Nebraska Public Power District

NLS2000075

Subject: Proposed License Amendment
Cooper Nuclear Station, NRC Docket 50-298, DPR-46

Title: Removal of Railroad Tracks from Figure 4.1-1, Site and Exclusion Area Boundaries and Low Population Zone.

Figure 4.1-1 (page 1 of 1)
Site and Exclusion Area Boundaries
and Low Population Zone

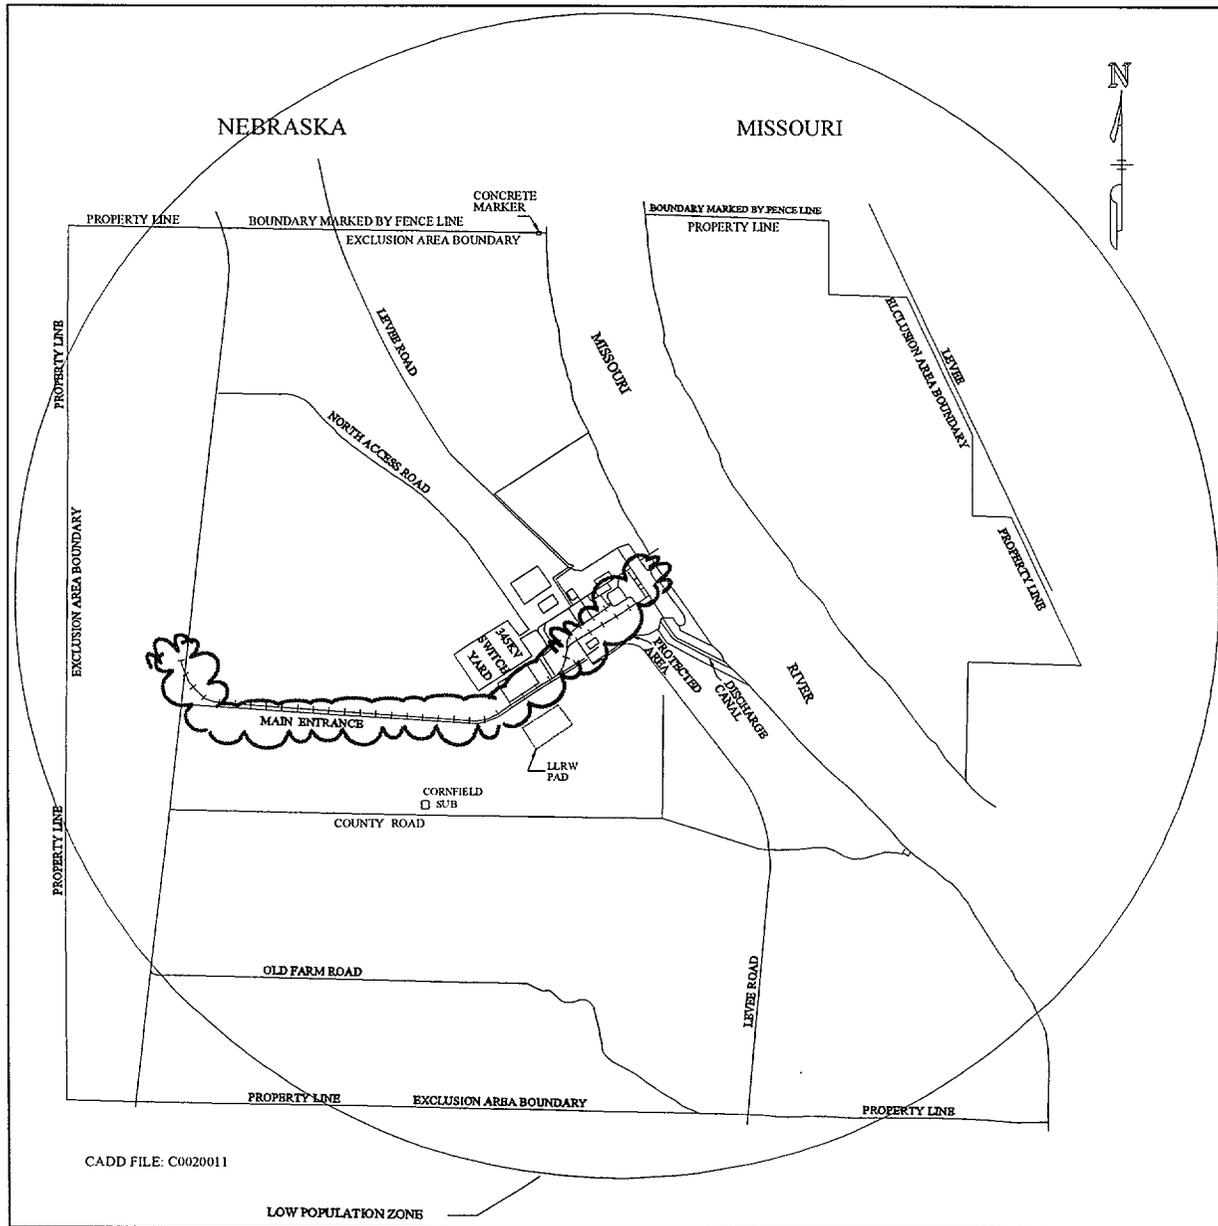
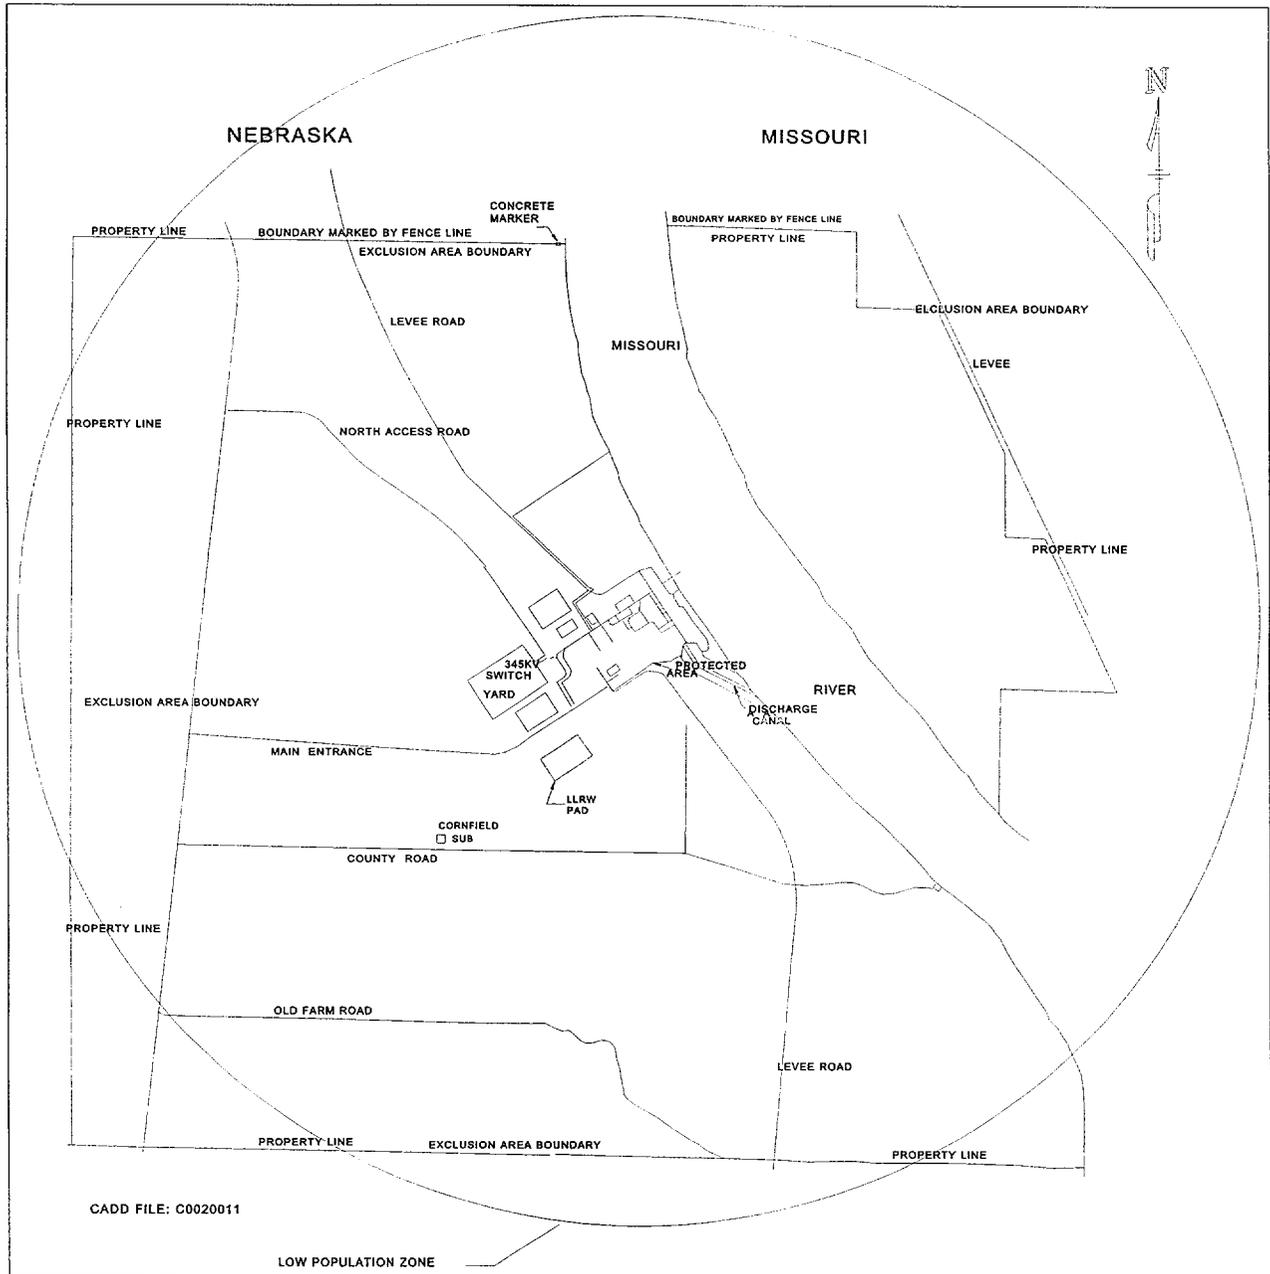
The proposed change would revise Technical Specifications Figure 4.1-1, "Site and Exclusion Area Boundaries and Low Population Zone" for Cooper Nuclear Station (CNS) to remove the depiction of railroad tracks along the main entrance road and into the plant and would change the text font within the figure for readability.

The rail line depicted in Figure 4.1-1 (Attachment 5) is a spur from the rail line to the CNS site used to provide transportation of heavy freight into and from the site which has since been abandoned in place. The figure shows the rail line next to the Main Entrance road as a cross hatched line which then splits into 3 branches that cross the Protected Area perimeter. The rail line is no longer used and serves no plant operational or safety function. Thus, it adds no significant information to the figure. This change proposes to remove depiction of these tracks from Figure 4.1-1. To improve readability,

especially for photocopies, this change also proposes to change the font of text within the figure to lettering without serifs. The proposed annotated TS page change, and final revised figure are included as Attachments 5 and 6.

In conclusion, the District requests the NRC to revise TS Figure 4.1-1, "Site and Exclusion Area Boundaries and Low Population Zone" to remove the depiction of railroad tracks along the main entrance road and into the plant, and change the text font within the figure for readability. The proposed change allows safe operation because it does not alter any safety systems, features nor analyses used in the design of the plant. Neither does it alter physical security or emergency provisions. Therefore, the District concludes that the activities associated with the above described changes present no significant hazards consideration under the standards set forth in 10 CFR 50.92 and accordingly, a finding by the NRC of no significant hazards consideration is justified.
